To: All Service Providers
From: M. Angela Foraker, Executive Director
Strategy, Sourcing, & Support
Date: November 4, 2022
Re: Addendum #1 for ITB 21368 – MetroHealth Clinic Upgrades at Clara Westropp, Mound, and Glenville

This Addendum #1 reflects the following:

New MetroHealth
ODH
SBHC
Health Care Expansion Program

2
A1.0
EXIST. / DEMO. CEILING PLAN
SCALE: 1/4" = 1'-0"

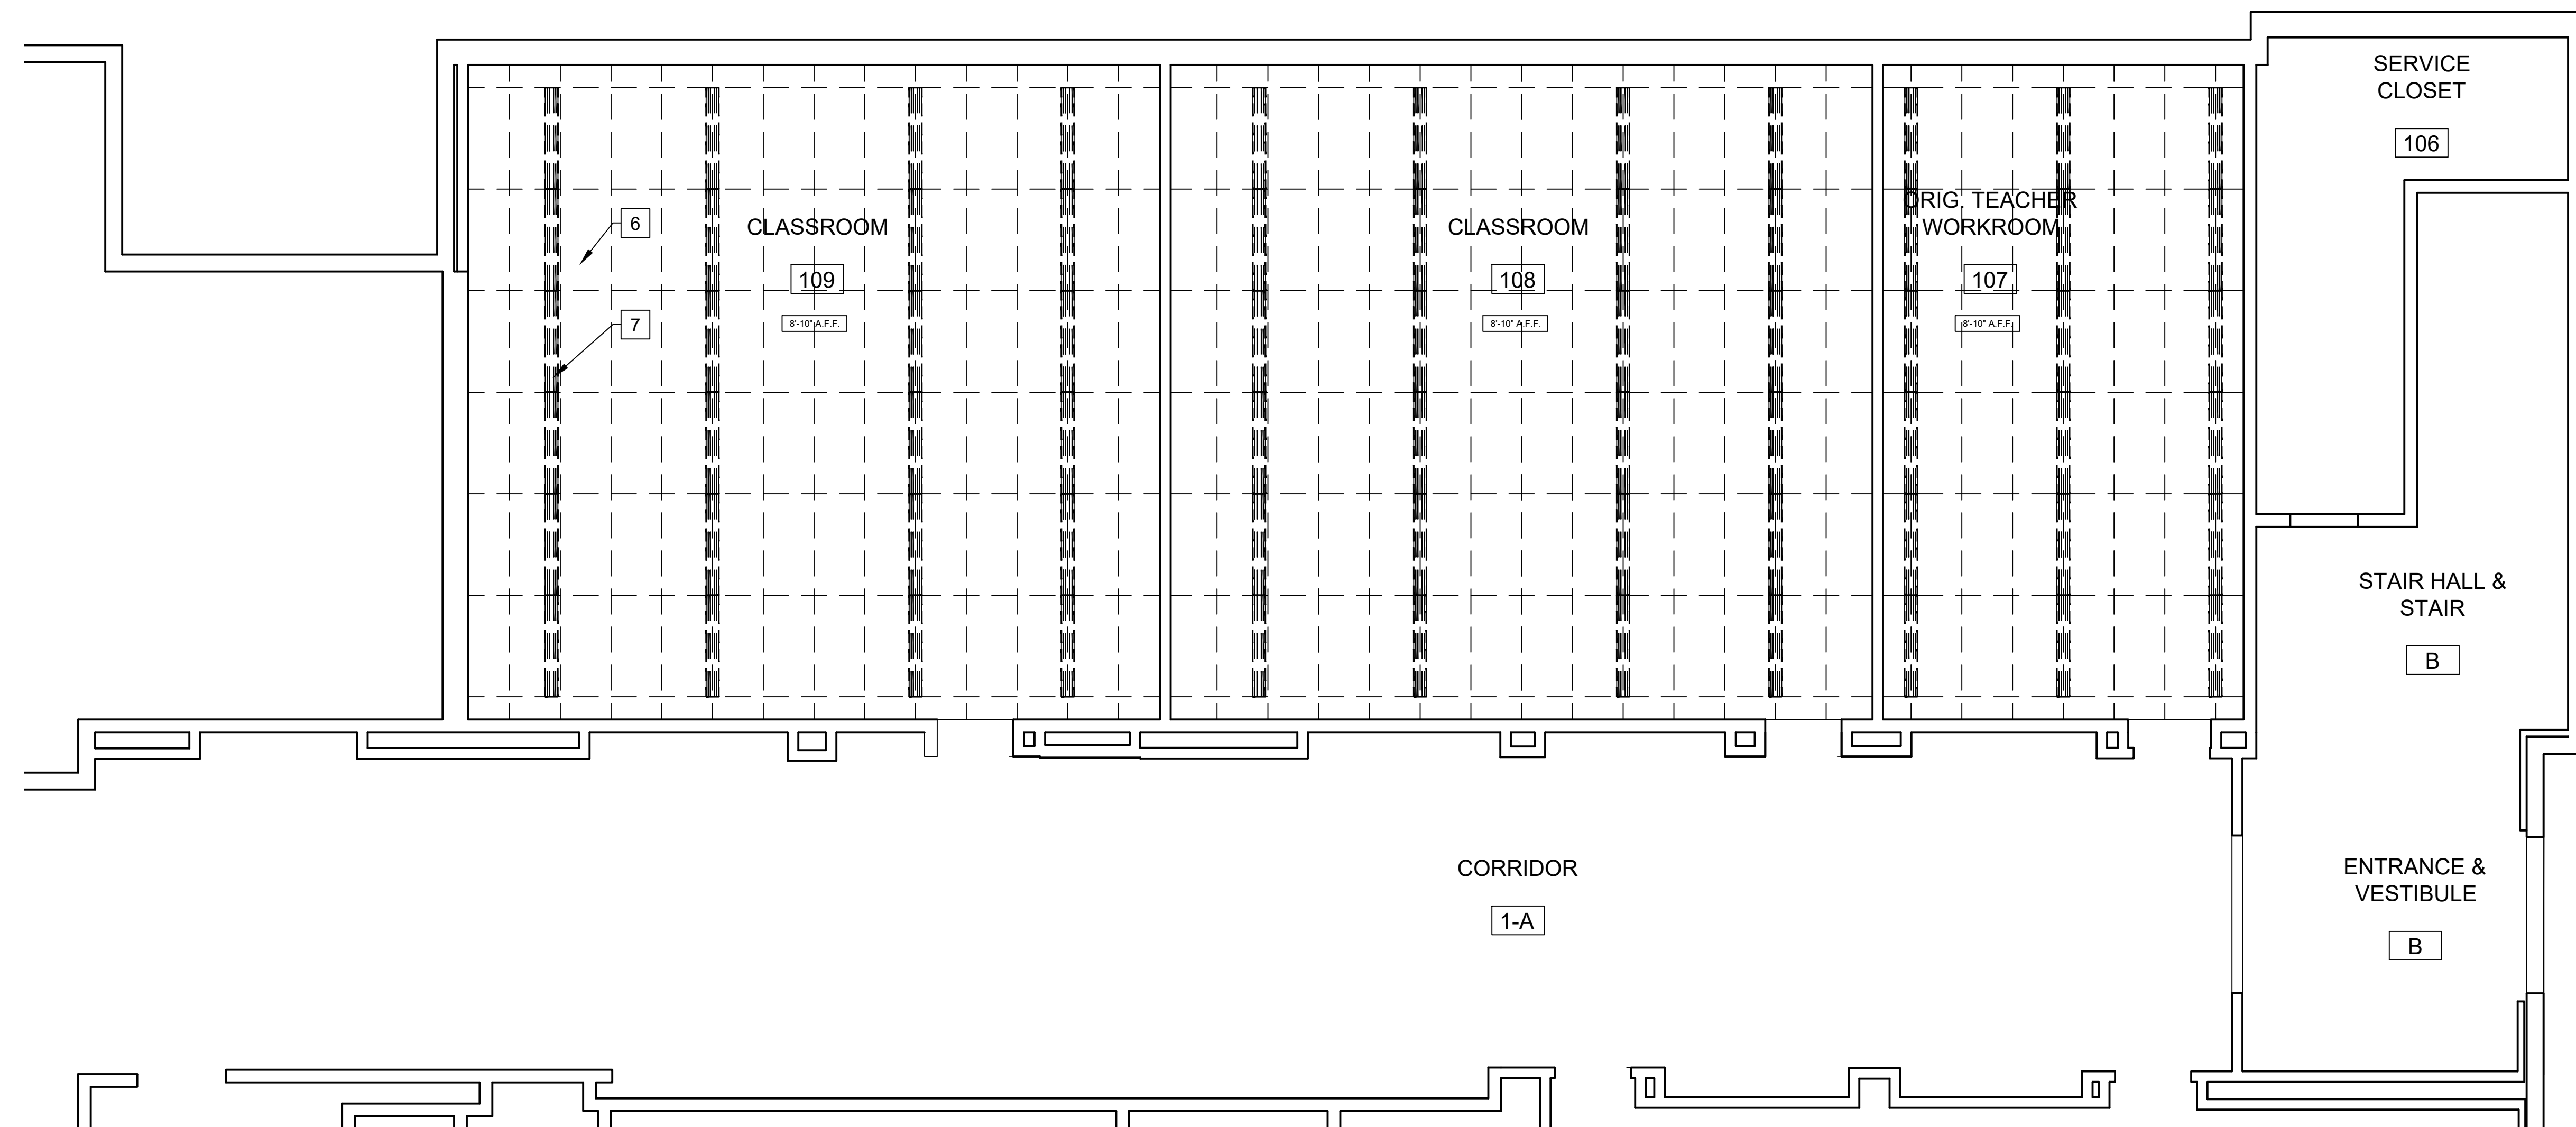
20. Glenville HS - Drawing A1.0 Exis/Demo Ceiling Plan - What are notes 6 and 7 indicate?

See Sheet A1.0 for notes

1
A2.0
PROPOSED FLOOR PLAN
SCALE: 1/4" = 1'-0"

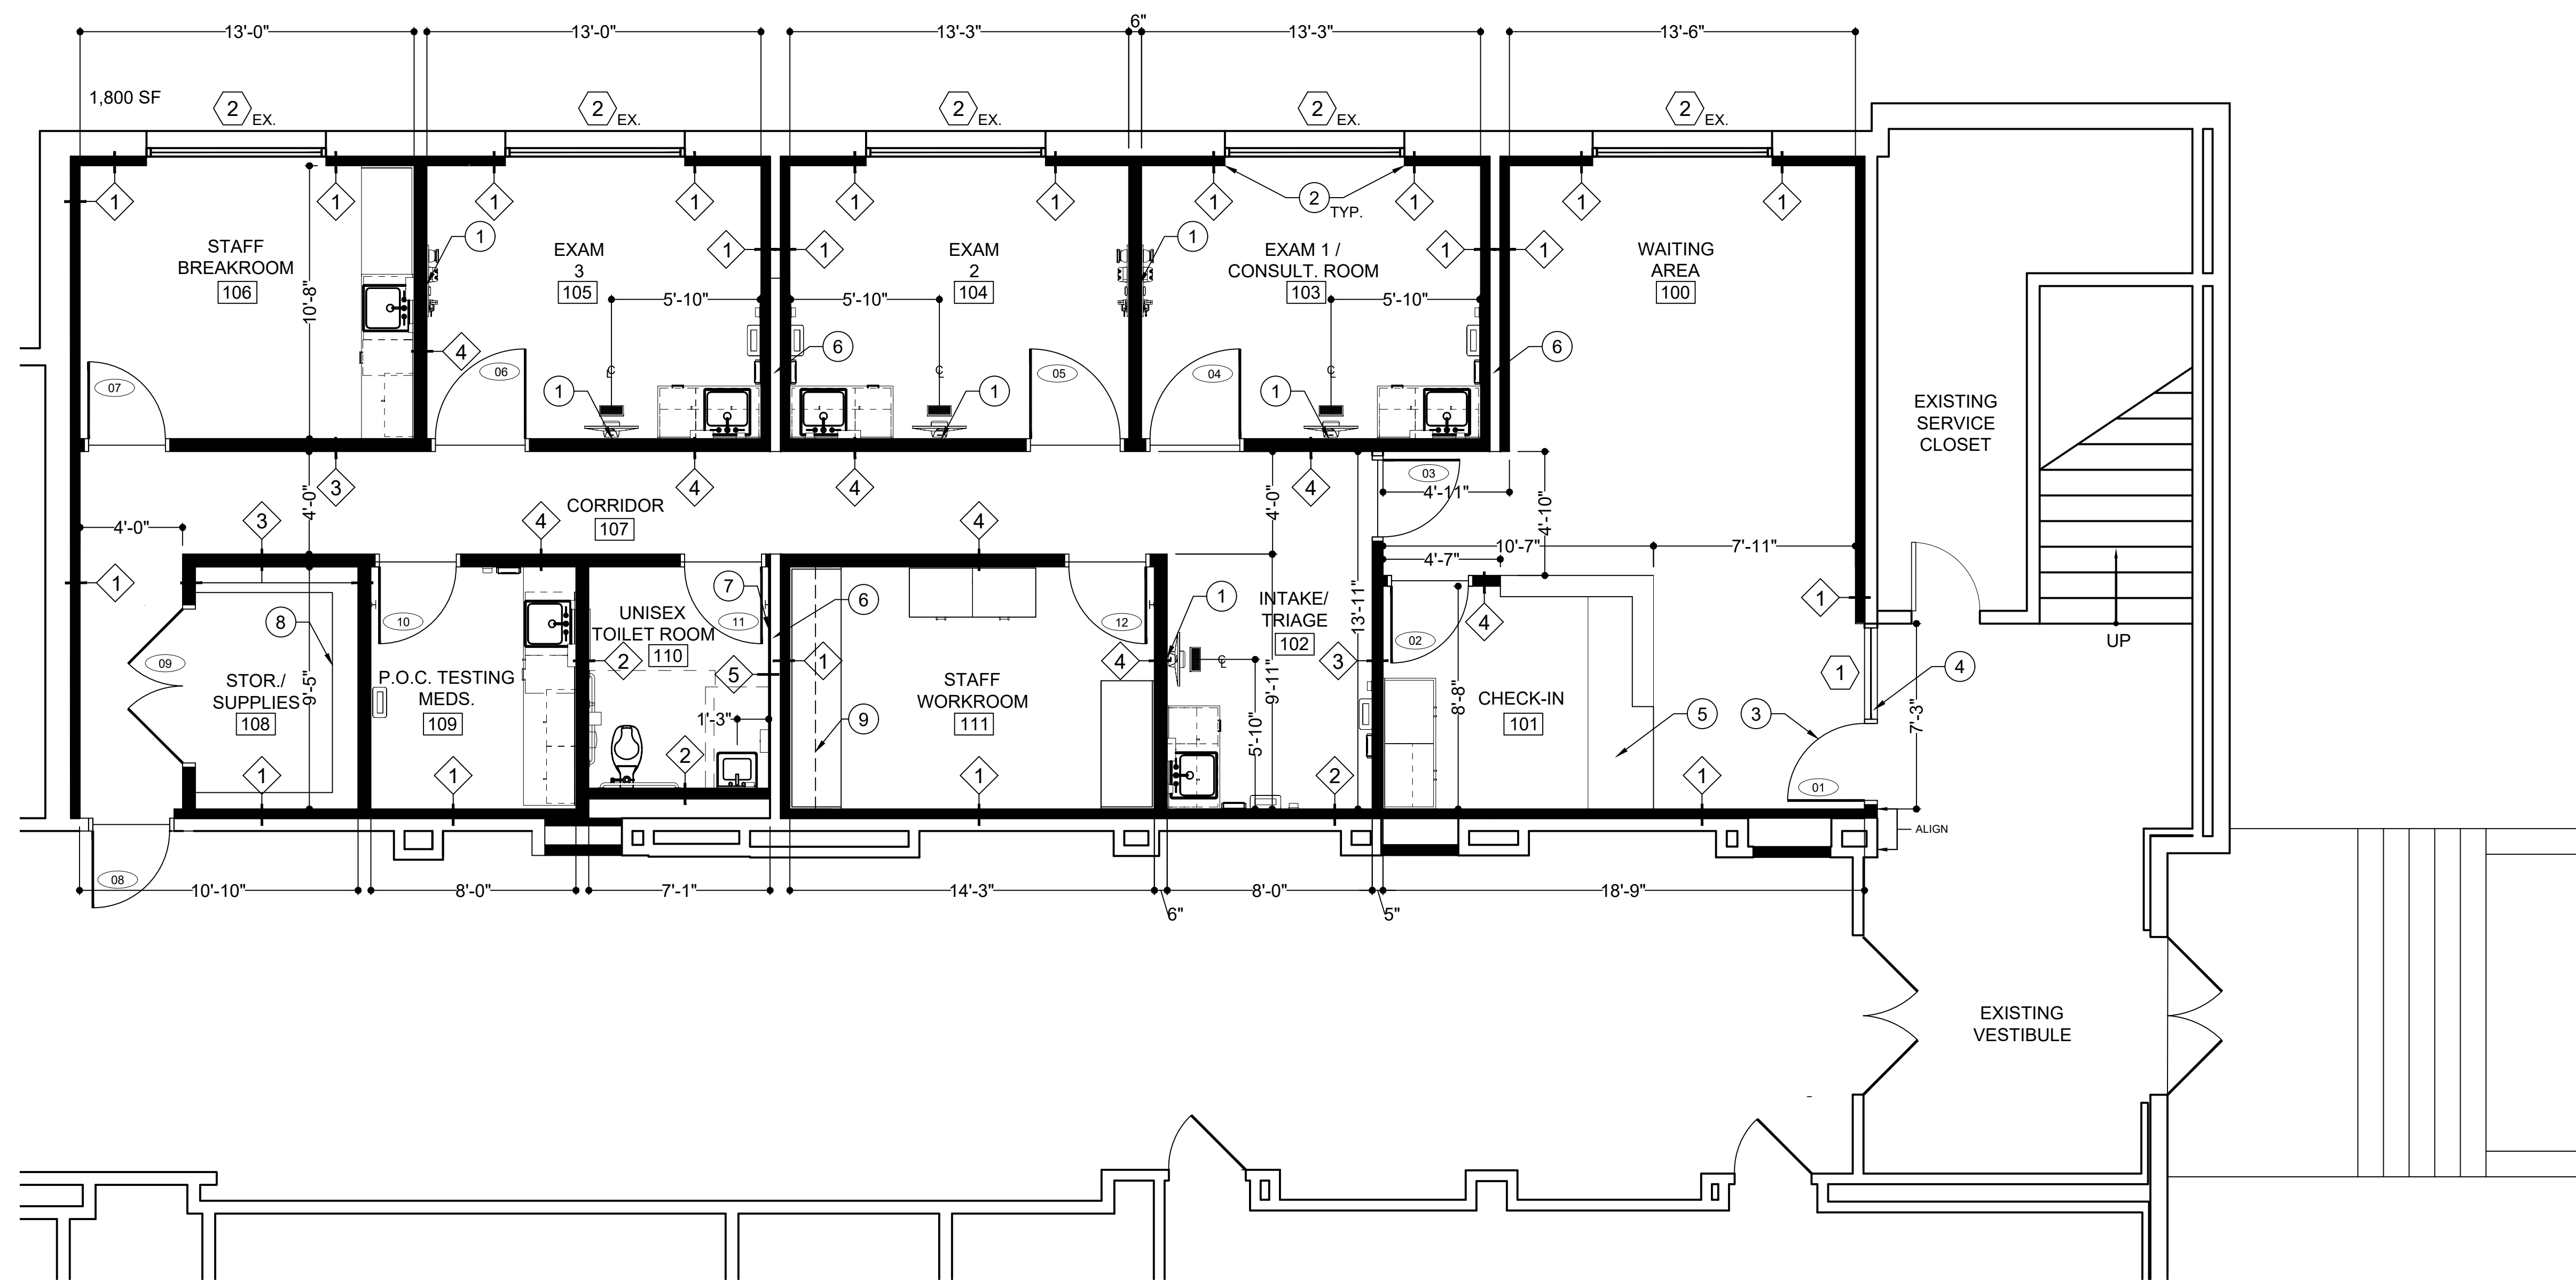
19. What is the hexagon symbol on proposed floor plan drawing(Clara Westropp)?

See Sheet A2.0 for notes

2 FURNITURE & EQUIPMENT PLAN
A4.0 SCALE: 1/4" = 1'-0"

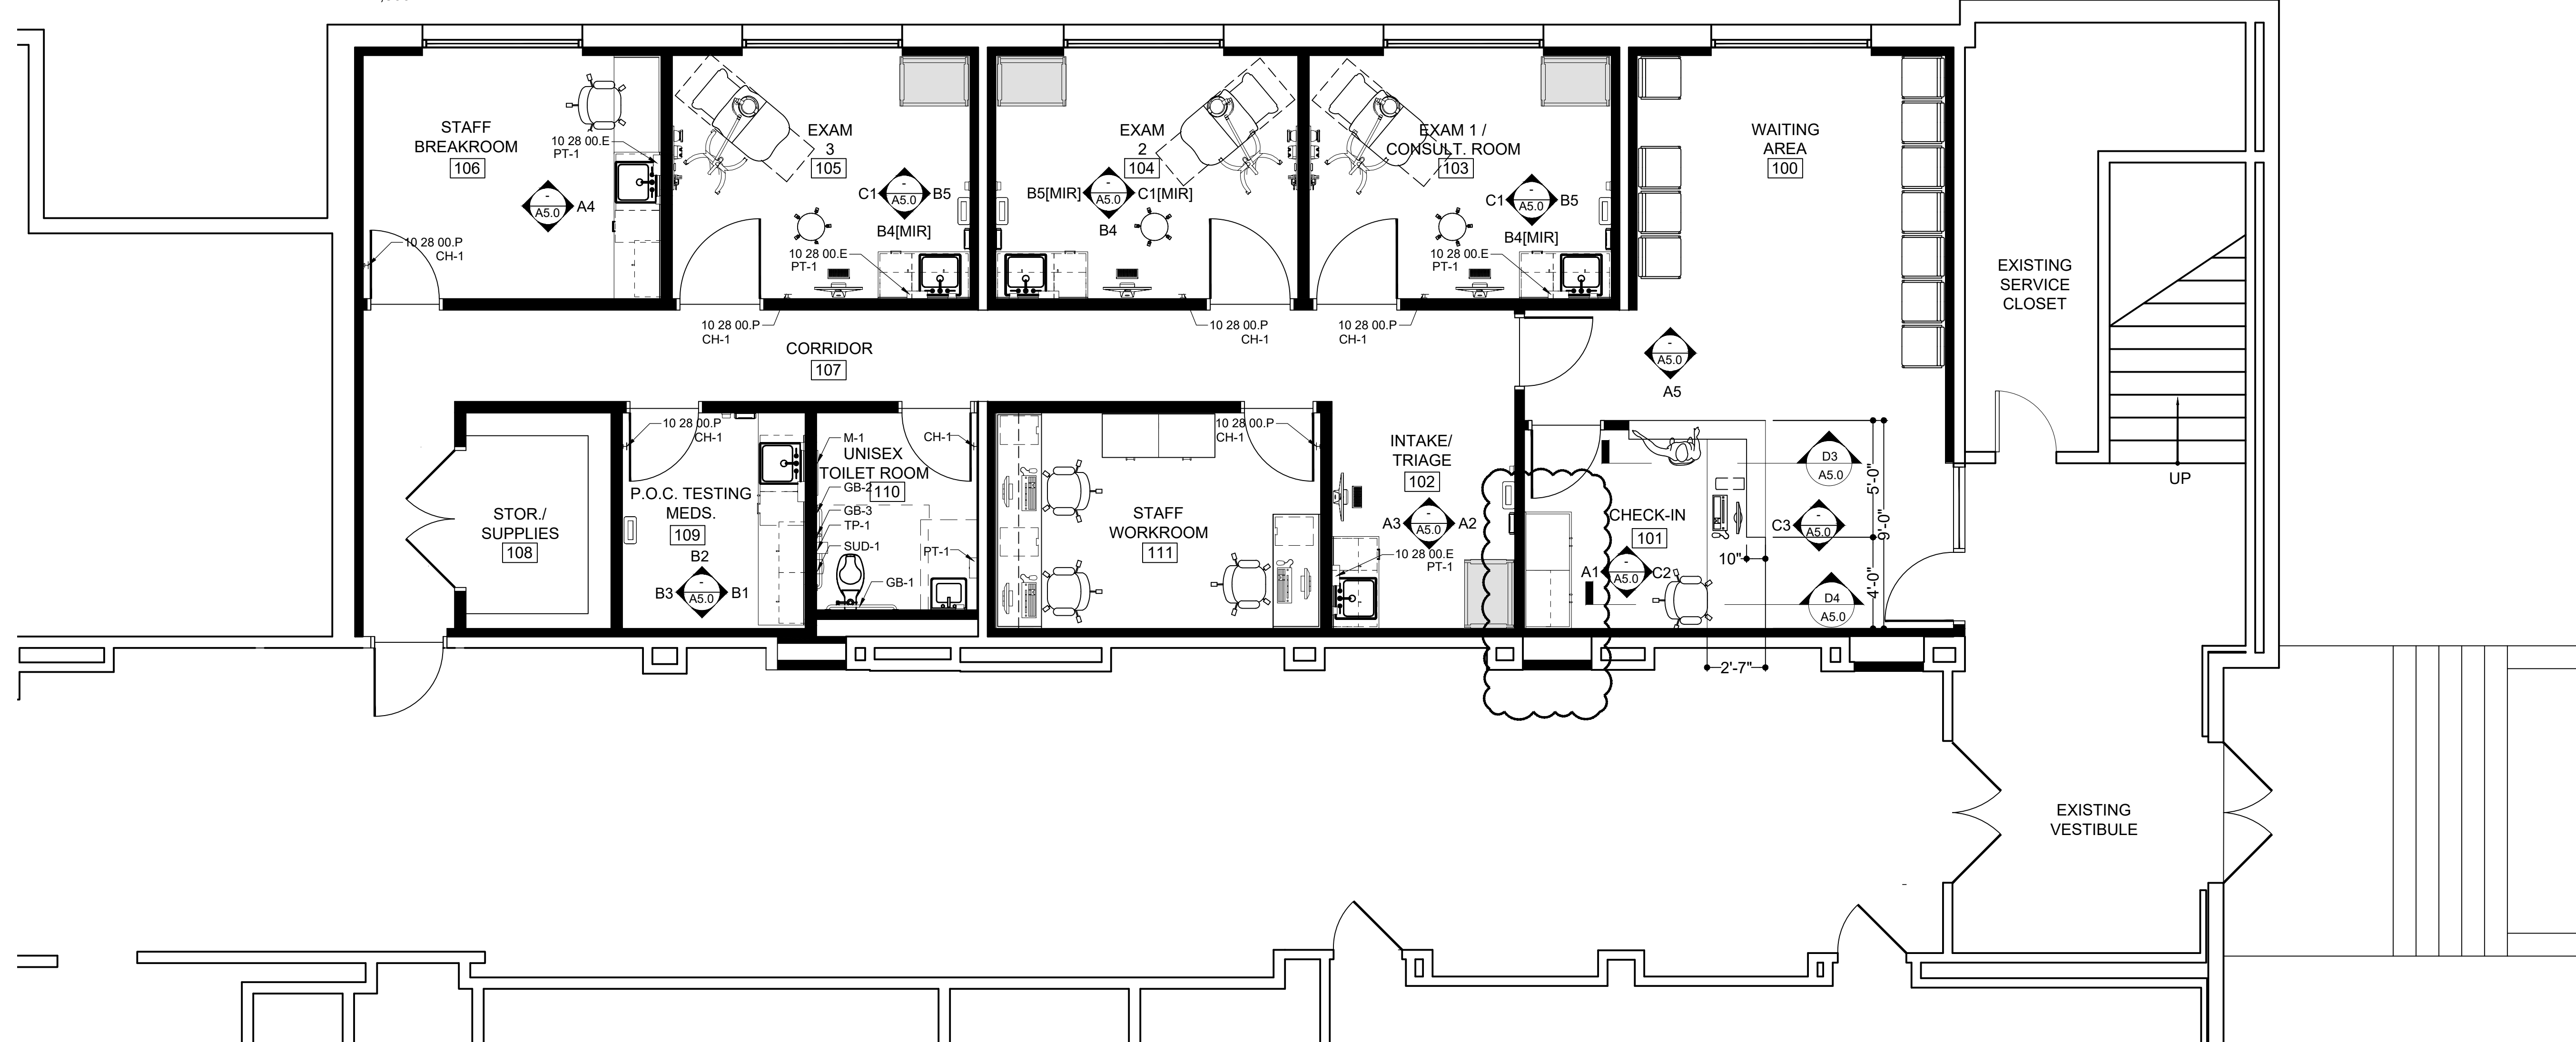
15. In Check-In 101, the floor plan shows what appears to be a tall cabinet with one base & one wall cabinet next to it. The elevation (A1/A5.0) shows two base and one wall cabinet. Which is correct(Glenville HS)?

See Sheets A4.0 and A5.0 for Revisions, two base and one wall cabinets
